**Board of Adjustment
Special Meeting Agenda
Fraser Town Hall, 153 Fraser Avenue
Wednesday February 26, 2025
5:30 PM - 6:30 PM**

a. Appeal Of Administrative Variance Denial - The Ascent

RE: The Ascent – Final Plat, Major Site Plan, Administrative Variance
Planning Review Comments (1st Referral Review)

LIGHTING PLAN
January 29, 2025
SHEET 13

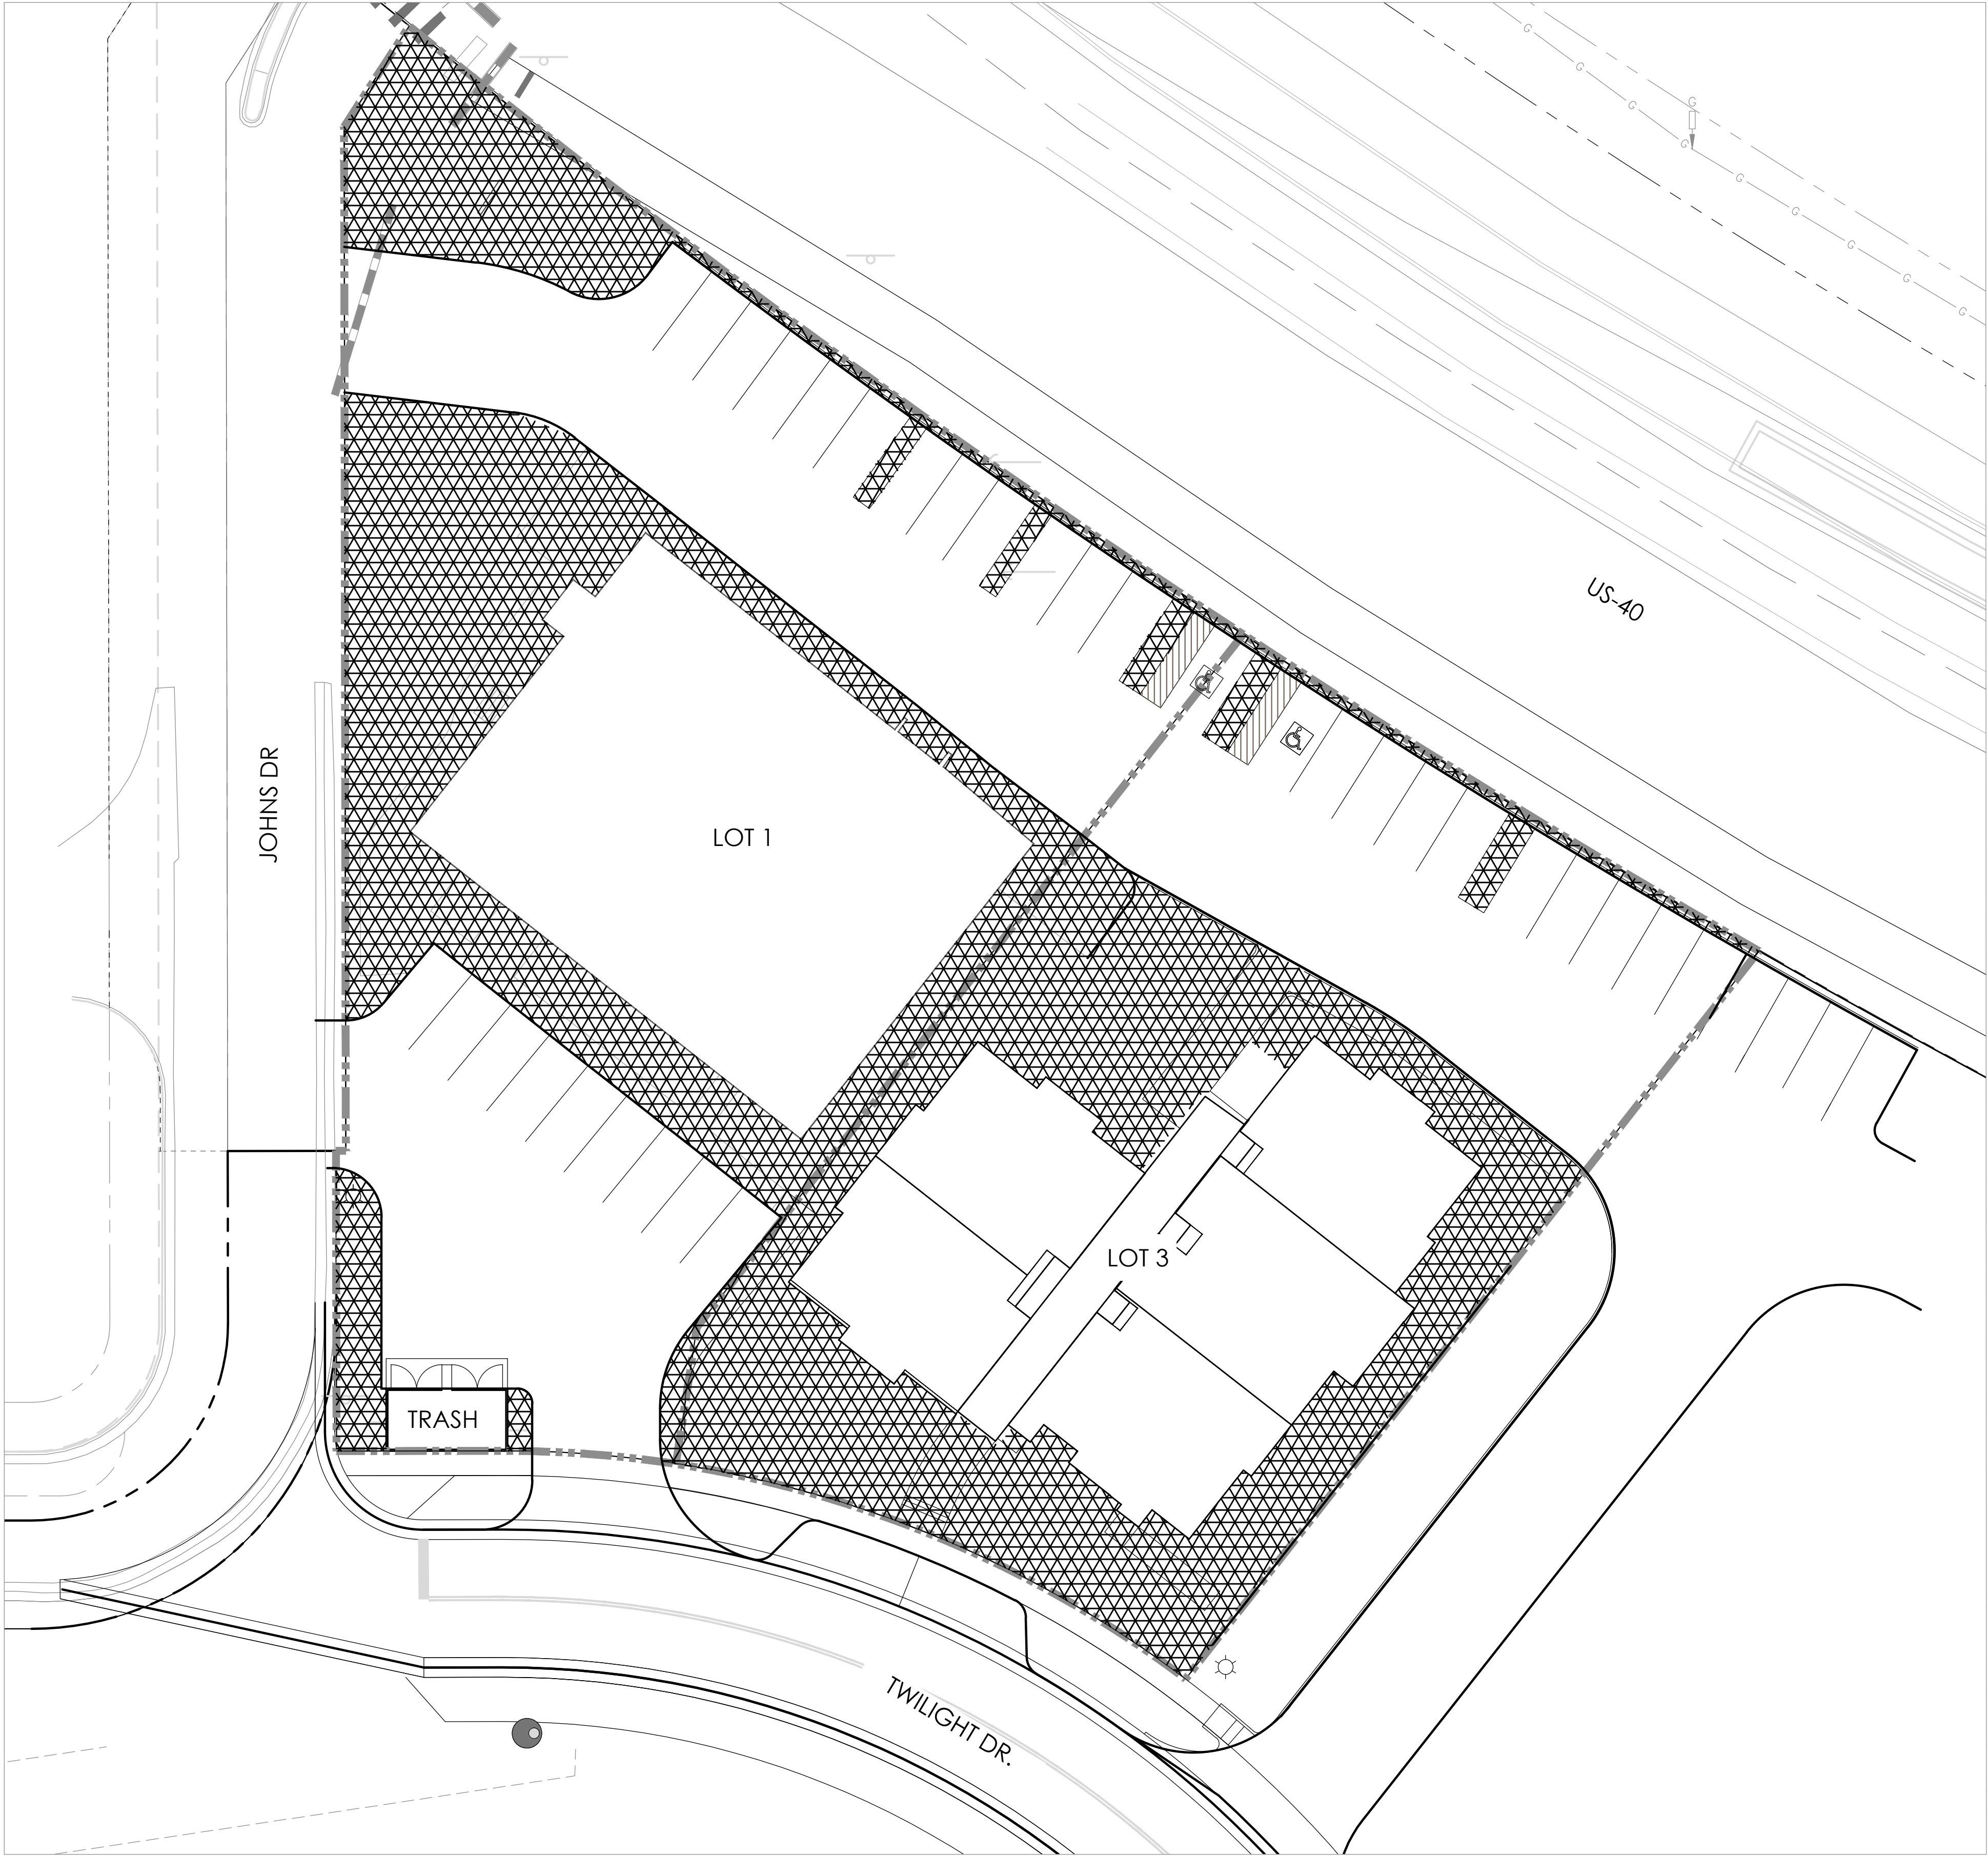
Sheet 12 – Lighting Plan

- 39) [Sec. 14-5-30](#) and [Sec. 19-4-195](#) include site lighting requirements and guidance for sites in the Business District zone. Lighting is to be appropriate for public safety and security, while minimizing undesirable effects of excessive illumination such as glare, sky glow and light pollution.
- a. The lighting plan provided only depicts existing pedestrian and parking lot lighting on the east side of the site. Please update the plan to include detail sufficiently addressing items 1 through 8 in Sec. 14-5-30.
 - b. You may incorporate the photometric plan as required in item (8) into this sheet.
 - c. Additional parking lot lighting is suggested for the southwest and southeast parking areas to provide minimal levels for pedestrian safety.
 - d. Please be sure to include any exterior lighting that is to be provided on the building exteriors into this sheet.
